ALDI Inc. Store #: 143  
 RAMSEY, MN  
 7992 SUNWOOD DR NW  
 RAMSEY, MN 55303  
 ANOKA  
 Project Name & Location:

<b>LANDSCAPE PLAN</b>	
Drawing Name:	ISG Project No.
Type: V7.0 ER	23-21339
Drawn By: AE	C-510
Designed By: AE	Drawing No.
Reviewed By: MRW

**1 - Changemark note #01 TL**

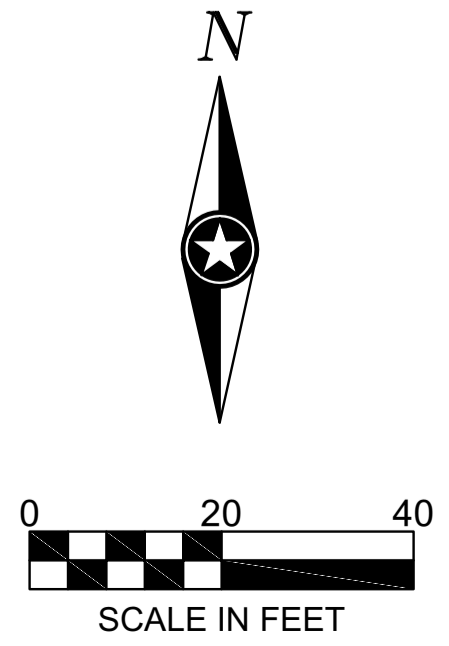
In lieu of at least 40% building frontage, you will need to add a decorative wall (see east end of Sunwood Drive) to provide the required hardscape.

Please consider foundation shrubs and plantings to enhance your sign base.

Where is snow likely to be stored?

The one place you have windows on the building you are blocking with evergreens. Please consider something else.

If all of this utility equipment must be here, please add a decorative screen wall.

Why are the trees planted so close to the parking lot? Why not center them in the green spaces?

This greenspace should be 'enhanced' somewhat by adding plantings (trees and shrubs).

Do not use riverrock in the parking lot islands. It's already a harsh growing environment and the rock will only absorb heat, which in turn heats the soil, baking the roots. Instead, use an organic type of mulch, such as wood chips or similar. This will not only aid in moderating soil temperature but will also help retain moisture.

Why would sod not be installed up to the edge of the sidewalk? Whatever groundcover exists currently will not have as nice of an appearance as the new sod.

Mountain Ash is at least somewhat intolerant of harsh urban areas. Suggest considering an alternate species for the parking lot islands.

This should be a thornless cultivar.
